D. O. Foster
Vice President
Vogtle Project

File: X7BG03-M83
Log: GN-788

Reference: Vogtle Electric Generating Plant-Units 1 and 2; 50-424, 50-425;
Westinghouse Flux Mapping System; Letter GN-699 dated 9/5/85.

WESTINGHOUSE FLUX MAPPING SYSTEM

FIGURE 1: MOVEABLE FRAME ANCHOR ANGLE STIFFENER

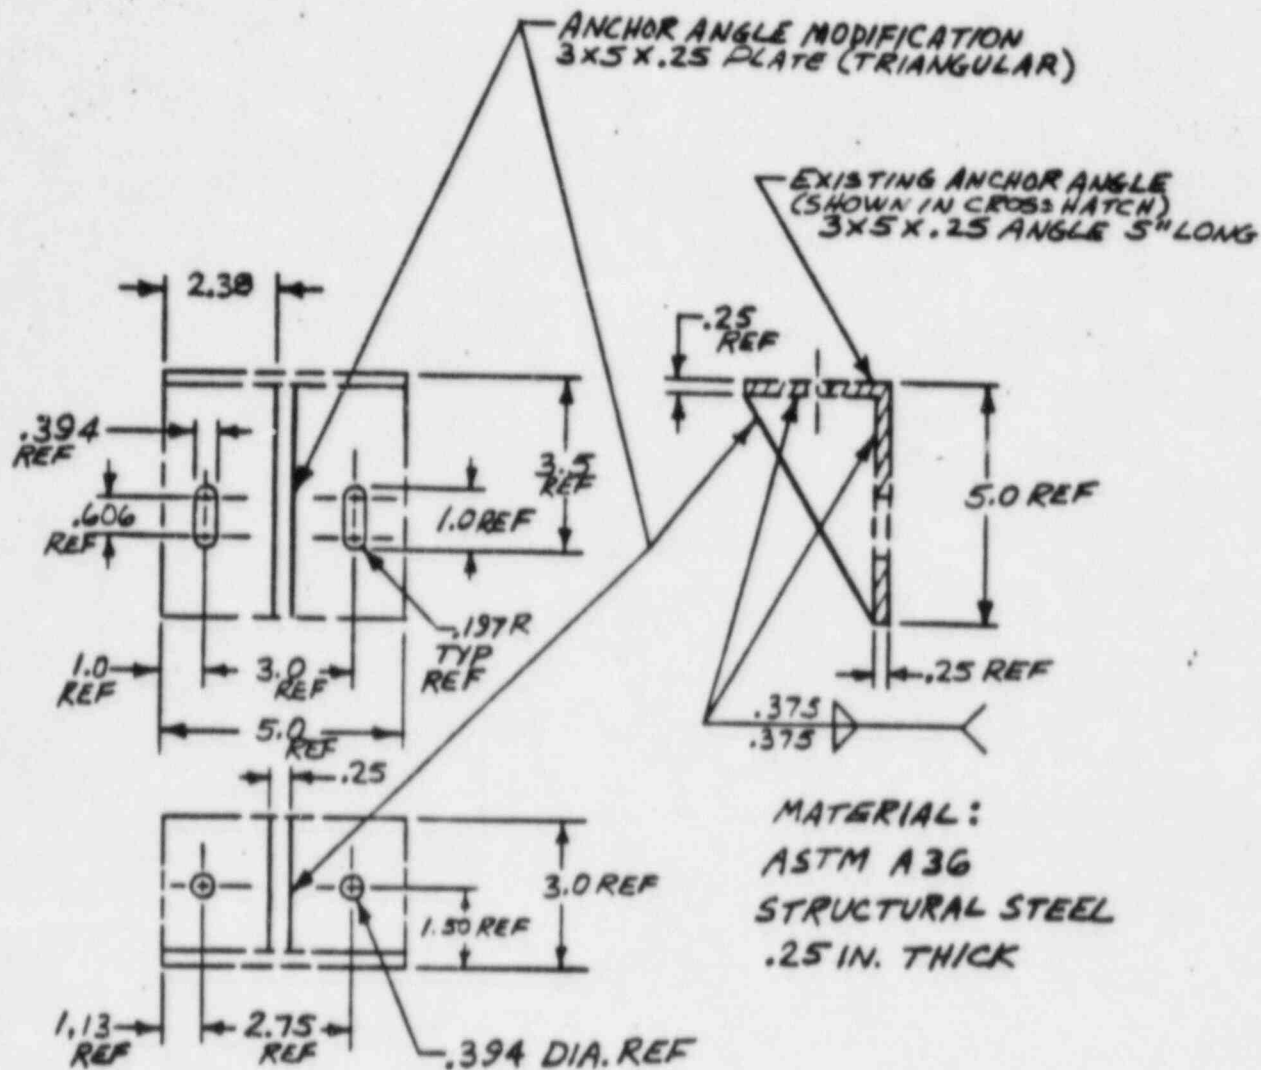
1. Add a 3" x 5" x 1/4" triangular plate stiffener to the moveable frame anchor angle using a 3/16" fillet weld as shown in Figure 1.
2. Place the modified anchor angle assemblies described above at the ends of each of the four (4) wheel assemblies as shown in Figures 2 and 3 to prevent possible liftoff and lateral movement along the rail direction. The anchor angle shown in Figure 1 are to be bolted to the I-Beams and to the anchor brackets shown in Figure 4.
